Arguments against Alternative 3

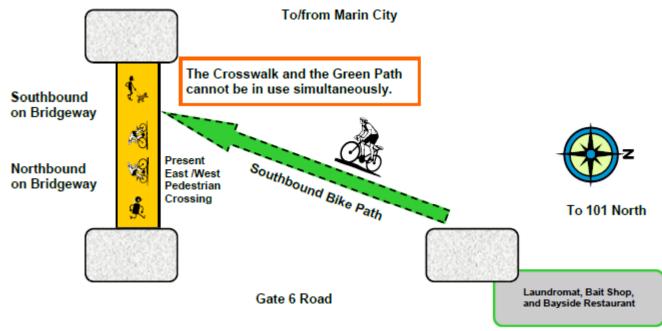
Alternative 3 will require even longer wait times for East-West traffic at Gate 6 Road than at present. Alternative 3 overlooks the existing crosswalk at the foot of Bridgeway. In addition to waiting for the bicycles to cross on the proposed new 'Green Path' additional wait time will be required for traffic at the crosswalk.

This increase in wait time will affect both West and Southbound automobile traffic coming from Gate 6 Road and East bound automobile traffic coming from the west (Marin City) side of the interchange.

Additionally, as it is presented, Alternative 3 will stop Northbound traffic at the foot of Gate 6 Road from making a right hand turn after stopping thus further restricting the flow of automobile traffic leaving Gate 6 Road.
